PUBLICATION INDEX

SGS 2-22

K & L SOARING, LLC
5996 STATE ROUTE 224
CAYUTA, NY 14824

BULLETIN NO. SA-102-33-1.2*

Figure 1 - Tube Dimension and Minimum Wall Thickness

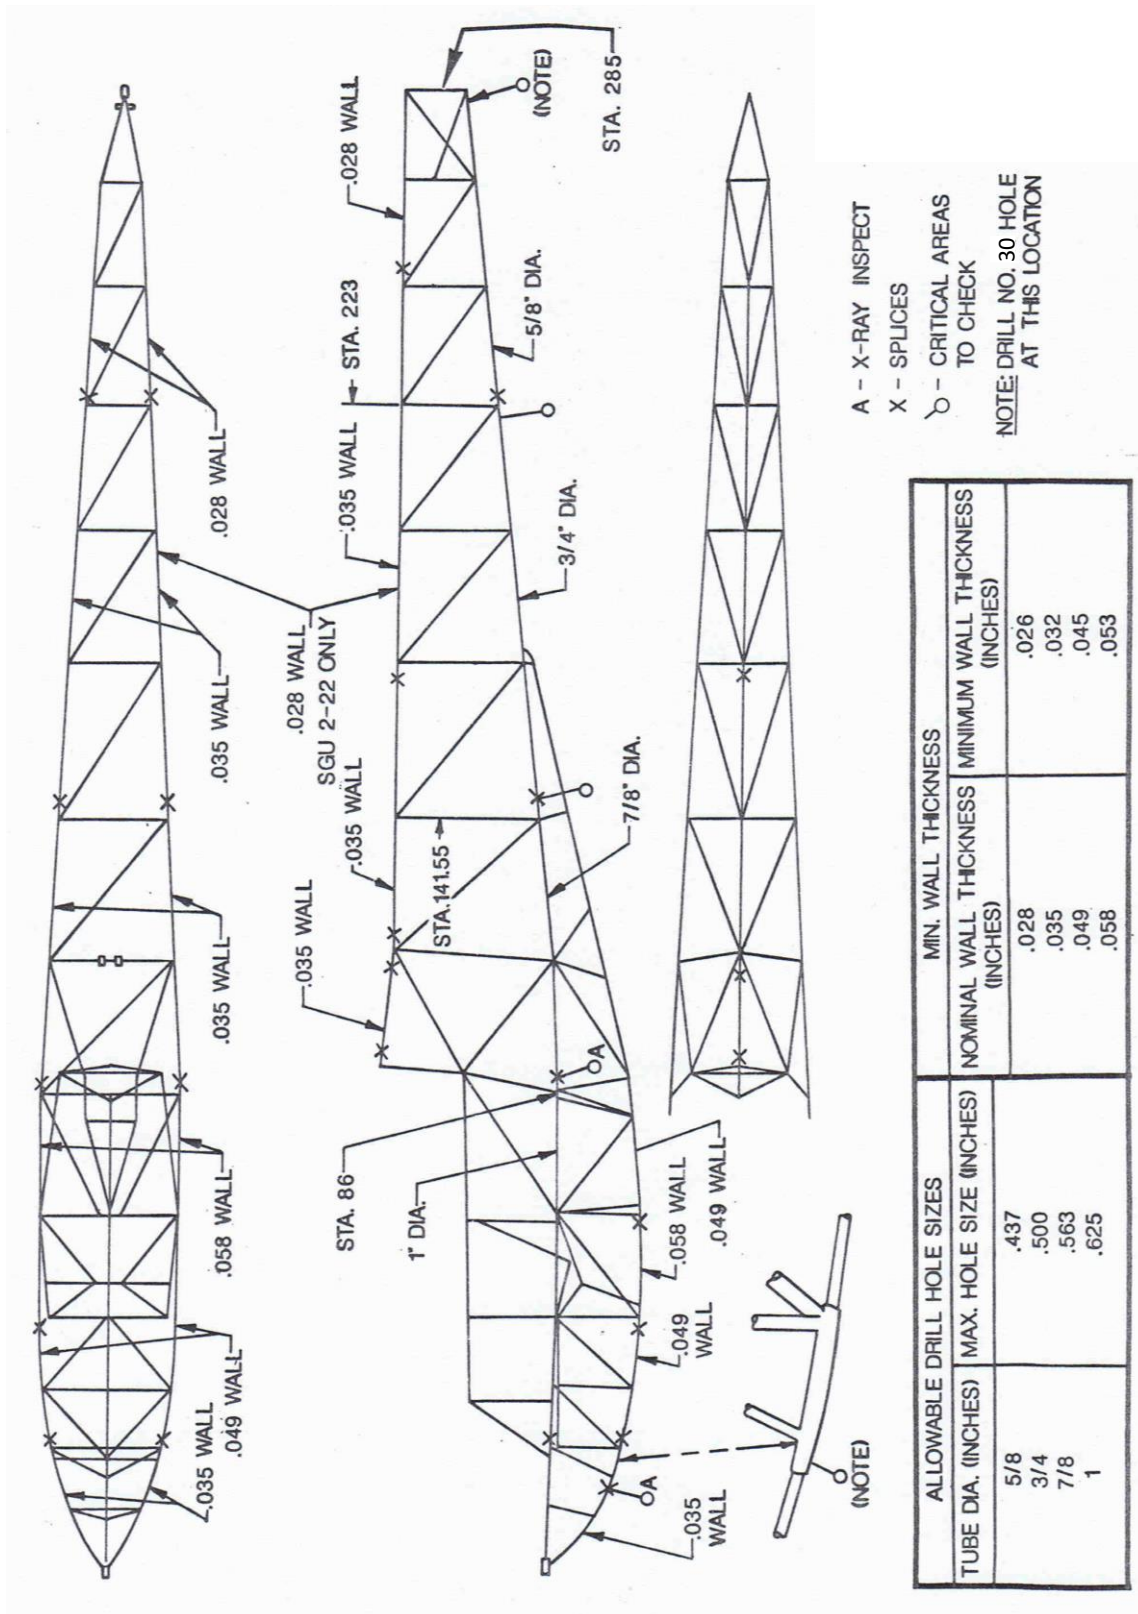
As an alternate to x-raying tubes for internal corrosion in next step, holes may be drilled at splices (areas marked A on Figure 1) to visually inspect the ID of the tubes. The holes should be drilled about 45 degrees in the lower outboard quarter of the tube just ahead of the splices. In the tail wheel area, enlarge number 30 holes to 7/16 inch maximum. (Refer to Figure 1 for other allowable hole sizes.) If corrosion exists, measure the wall thickness as shown in Figure 2. Tubes which have a wall thickness which is less than the limit specified in Figure 1, must be replaced.

- C. If water drains from holes, x-ray inspect splices of longeron tubes that are marked A on Figure 1.
- D. If any corrosion is evident, proceed as follows:
- a. Drill holes at suspect locations. (Refer to Figure 1 for maximum allowable hole size)
 - b. Measure the wall thickness as shown in Figure 2.
 - c. If wall thickness is less than the required limit (specified in Figure 1), repair or replace the tube in accordance with AC 43.13

- E. Visually inspect longeron tubes for external corrosion from inside the aircraft.
- F. If external corrosion is evident, drill holes and measure wall thickness in accordance with steps D (a) and D (b) above. If wall thickness is less than required limit (specified on Figure 1), repair or replace tubes in accordance with AC 43.13.
- G. With a dull ice pick, perform a prod test at one inch intervals along entire length of the lower surface of the longerons from station 141.55 aft to station 285.00. If ice pick penetrates tube, drill holes and measure wall thickness as specified by steps D (a) and D (b) above. If wall thickness is less than the required limit (specified on Figure 1), repair or replace tubes in accordance with AC 43.13.

Figure 4 – Pressure Check Gauge

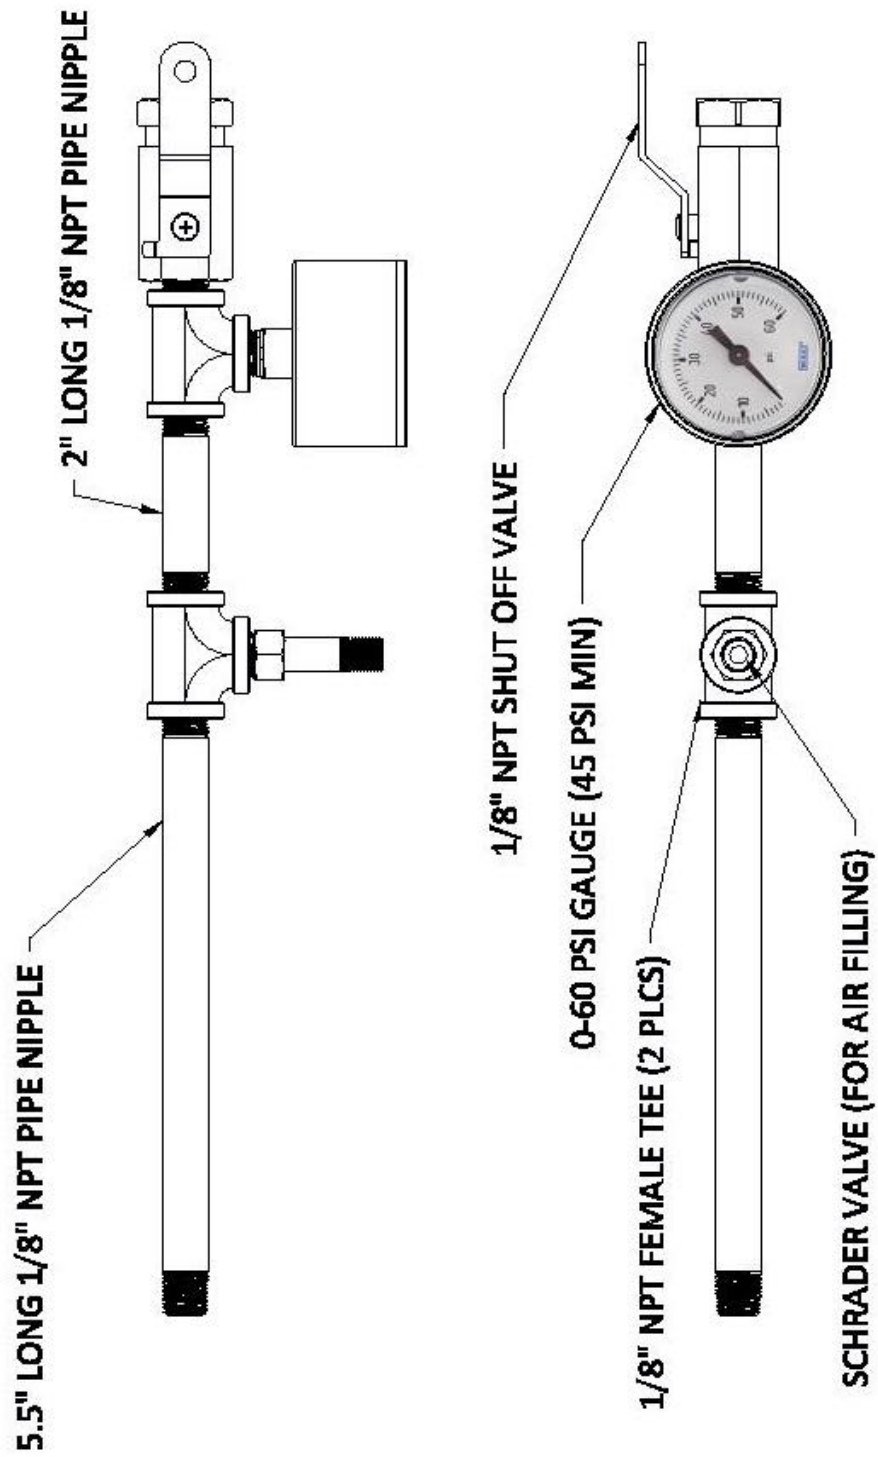
1. Reinstall all plugs except behind rear seat in upper longeron
 2. Install a pressure check gauge similar to what is shown in Figure 4 in upper longeron behind rear seat
 3. Using compressed air fill fuselage up to 30 psi. Wait 1 hour and then refill fuselage to 30 psi
 4. Wait 6 hours. If fuselage pressure is below 15 psi the fuselage fails pressure check and K&L Soaring must be contacted before returning aircraft to service.
- C. Reinstall threaded plugs from oiling kit
 - D. Record compliance with this Service Bulletin in the Aircraft Log Book

FIGURE 1 – ENGAGEMENT OF TOW HOOK INTO RELEASE ARM

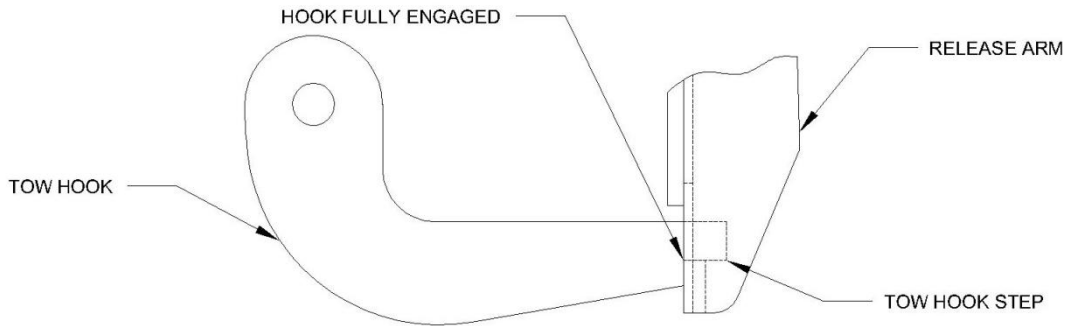
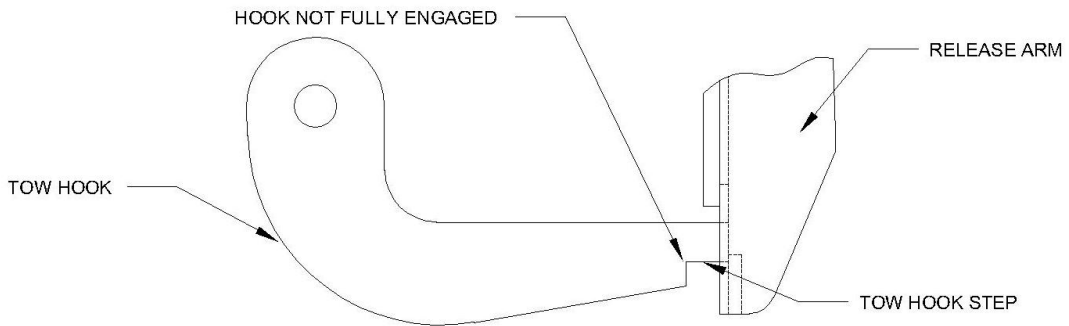
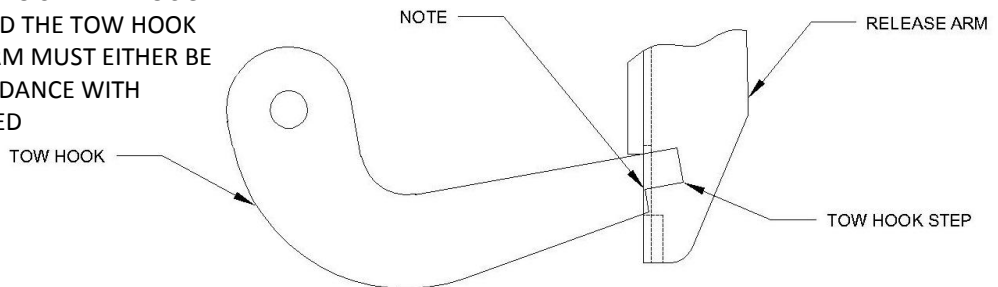
OVERVIEW: The .5 revision is the same as the .4 revision except changes to Figures 1, 3, & 4. Figure 1 has changed to add View D to show improper engagement. Figure 3 has been changed to show proper release arm cutout. Figure 4 has been changed to show proper readings for the C.G. hook install.

- Proper engagement of the tow hook into the release arm is shown in Figure 1, View A, and Figure 4. Excessive wear of the tow hook step could result in improper engagement. Figure 2 of this bulletin provides inspection data and wear limits for the tow hook. Tow hooks which do not meet the specified limits must either be reworked to obtain dimensions (as specified in Figure 2) or replaced.
 - If tow hooks is able to slide into the release arm, beyond the tow hook step, as shown by Figure 1, View C, the release arm must either be reworked with a slug as specified in Figure 3, or replaced.
- c. Inspect tow hook for wear in accordance with Figure 2 of this bulletin.

- d. If tow hook dimensions are not within limits specified in Figure 2, either rework the tow hook to obtain dimensions (as specified in Figure 2) or replace it with a new or serviceable, used tow hook
- e. Engage tow hook into release arm. Ensure that the tow hook properly engages as shown in Figure 1, View A.
- f. If tow hook is unable to completely engage (shown by Figure 1, View B) shorten the rubber bumper stop between the release knob and the instrument panel to allow the release assembly to close further.

- g. If tow hook is able to travel too far inboard as shown in Figure 1, View C, disengage tow hook from release arm and measure the length of the release arm slot
- h. If dimension is less than 0.66 inch, rework release arm by welding on 1B-217-19 slug at location shown in Figure 3. (Release arm may be replaced as an alternate to welding on slug)
- i. If length of release arm slot is greater than 0.66 inch, replace release arm.
- j. Perform a thorough inspection of the tow hook installation in accordance with the 100 hour inspection requirements listed in Table 2 of this bulletin.
- k. Repair or replace unserviceable component(s), as required
- l. Record compliance with Part I of this Service Bulletin in Aircraft Log Book.

- Figure 1 shows the proper attachment of the tow hook into the release arm. Note that the step of the tow hook should seat against the release arm. The tow hook step must fully engage the release arm to allow the release assembly to function properly. The tow hook must not be allowed to extend through the release arm beyond the step on the hook as shown in Figure 1, View C.

IF TOW HOOK IS ABLE TO SLIDE THROUGH RELEASE ARM, BEYOND THE TOW HOOK STEP, THE RELEASE ARM MUST EITHER BE REWORKED IN ACCORDANCE WITH FIGURE 3, OR REPLACED

FIGURE 4 - PULL TEST OF TOW RELEASE ASSEMBLY

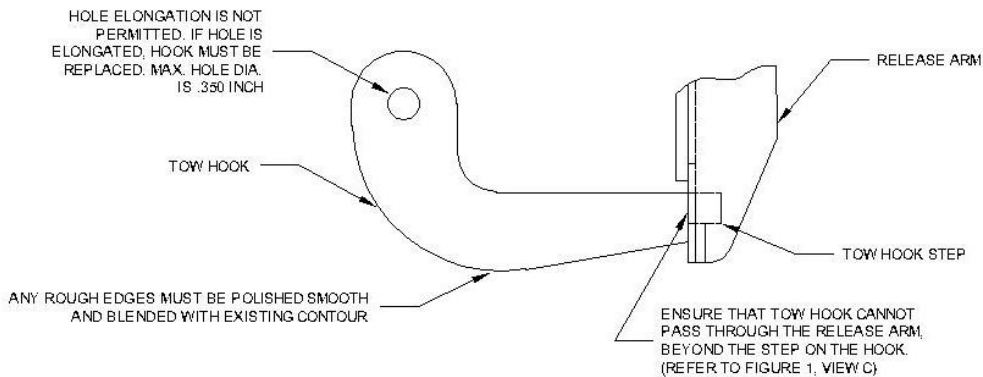
Perform a release check for proper release tension in accordance with Figure 4.			X
Lubricate attach hardware for tow hook and release arm.		X	X
Lubricate guide-tubes in release control with dry stick type lubricant.		X	X
Insure that tow hook moves freely on pivot bolt.	X	X	X

NOTE: IF RELEASE LOADS ARE TOO HIGH WITH C.G. SYSTEM IT IS PERMISSIBLE TO ADD A LINK TO SHORTEN STD 1A141-2 SPRING. LINK SHOULD BE MADE AS SHOWN BELOW. IF REQUIRED THEY SHOULD BE ADDED TO BOTH RELEASE ARMS TO BALANCE BOTH RELEASE SPRINGS
